FCC Class II Permissive Change Request Letter

RE: FCC Permissive II Change Request for Company: Ohsung Electronics Co., Ltd. **FCC ID:** OZ5URC-SR002C

We are submitting an application for a class II permissive change to the FCC approval of the Company name: Ohsung Electronics Co., Ltd., product description: Remote Controller (FCC: **OZ5URC-SR002C**, Original Grant Date: Jun. 04, 2019). The transmitter module itself has not changed. Here are the changes:

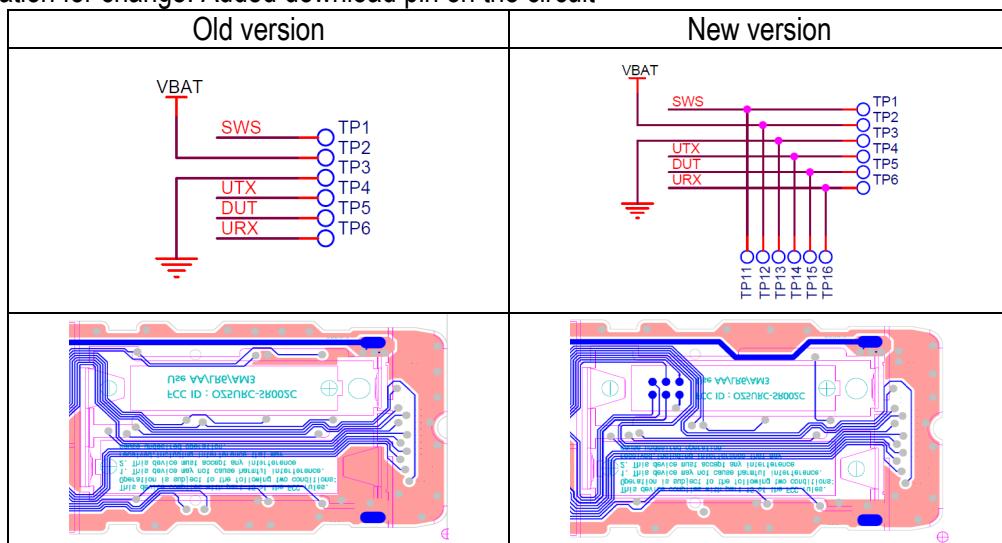
1. Main PCB version

- Old version: PFFFA1454A(OTMF-B910TYPE) 2019.05.13
- New version: PFFFA1454A(OTMF-B910TYPE) 2019.09.04

2. Information for change: Added download pin on the circuit

※ Only non-transmitter parts itself has changed.
